# Technical Service Bulletin

## 20 Noises from the fuel line

20 20 27 2059997/1 July 7, 2020.

**Figure 1.** Location of fuel line of vibration.

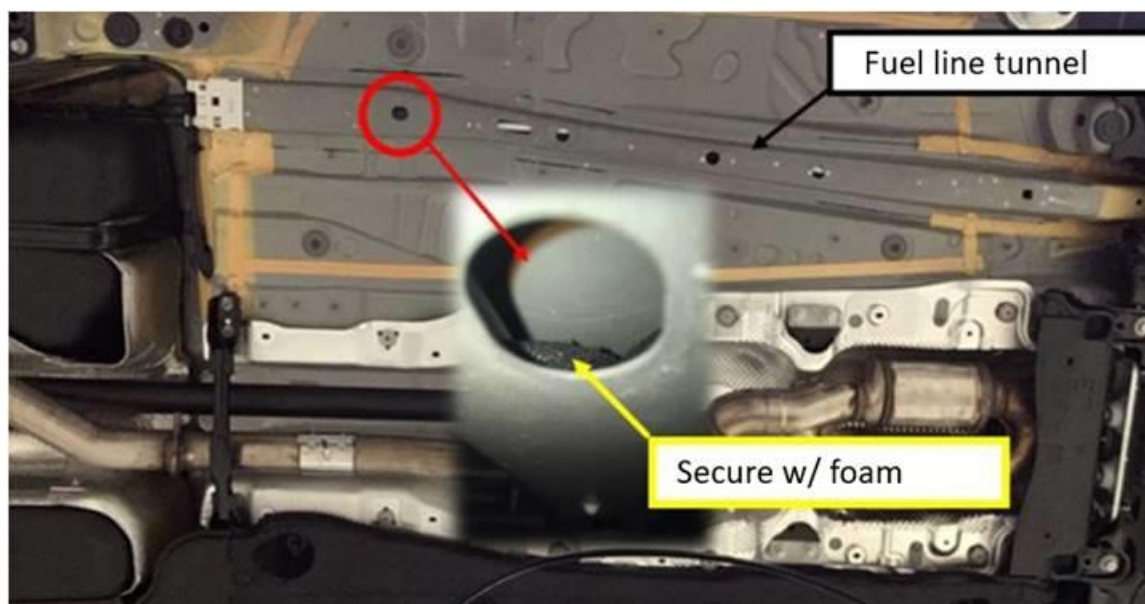
- The fuel lines in the longitudinal member start to vibrate in certain operating situations and this creates the noise.

Due to pressure pulsation from the high-pressure pump on engine side the underfloor line in the underbody tunnel vibrates. This vibration causes noise that can also be heard in the vehicle interior.

1. Remove the underbody cover.
2. Fill the fuel line tunnel or the space around the line with closed-pore foam (foam that doesn't soak up water) part number 321 201 299. This means the fuel line does not have to be removed.

4. Reinstall the underbody cover.
